UNITED STATES  
NUCLEAR REGULATORY COMMISSION  
WASHINGTON, D.C. 20555-0001

May 26, 2017

**SUBJECT: DUANE ARNOLD ENERGY CENTER – SAFETY EVALUATION REGARDING IMPLEMENTATION OF MITIGATING STRATEGIES AND RELIABLE SPENT FUEL POOL INSTRUMENTATION RELATED TO ORDERS EA-12-049 AND EA-12-051 (CAC NOS. MF1000 AND MF1001)**

**Figure 1 - Duane Arnold SFP Levels of Monitoring**

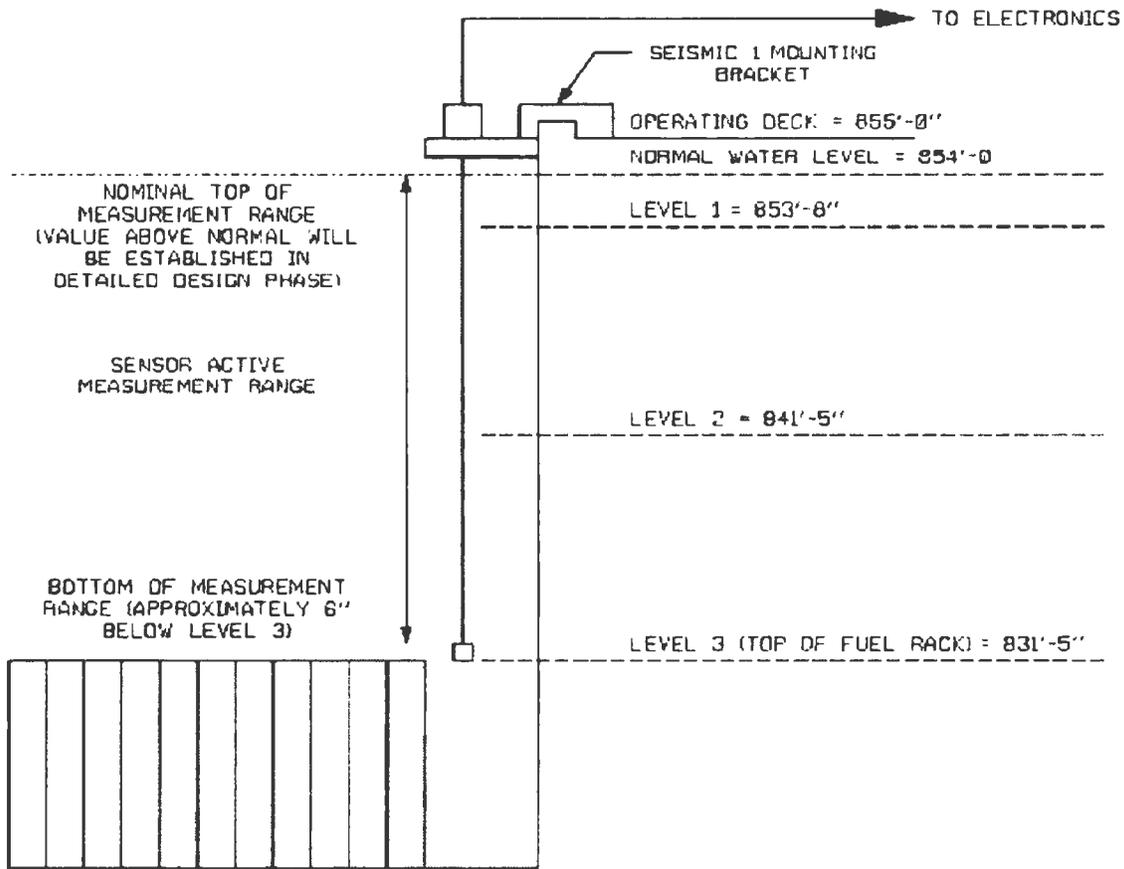
In its letter dated October 10, 2013, the licensee provided a sketch depicting the SFP levels of monitoring and the measurement range for the instrument channels as illustrated below in Figure 1, "Duane Arnold SFP Levels of Monitoring".

Per NEI 12-02, Section 2.3.1, Level 1 will be the higher of two points. The first point is the water level at which suction loss occurs due to uncovering of the spent fuel cooling system inlet pipe, weir or vacuum breaker. The second point is the water level at which loss of spent fuel cooling pump NPSH occurs under saturated conditions. Duane Arnold designated Level 1 (853'-8") based on the normal water level in the SFP. According to the licensee, this water level is above the SFP weir wall elevation that is needed to ensure adequate SFP cooling flow. Duane Arnold's Level 1 is the higher of the above two points, and therefore, appears consistent with NEI 12-02. Level 2 was identified by the licensee as elevation 841'-5". This level is consistent with the first of the two options described in NEI 12-02 for Level 2, which is 10 ft. (+/- 1 foot) above the highest point of any fuel rack seated in the SFP. Level 3 appears to be consistent with NEI 12-02 Level 3, which is the highest point of any fuel rack seated in the SFP.
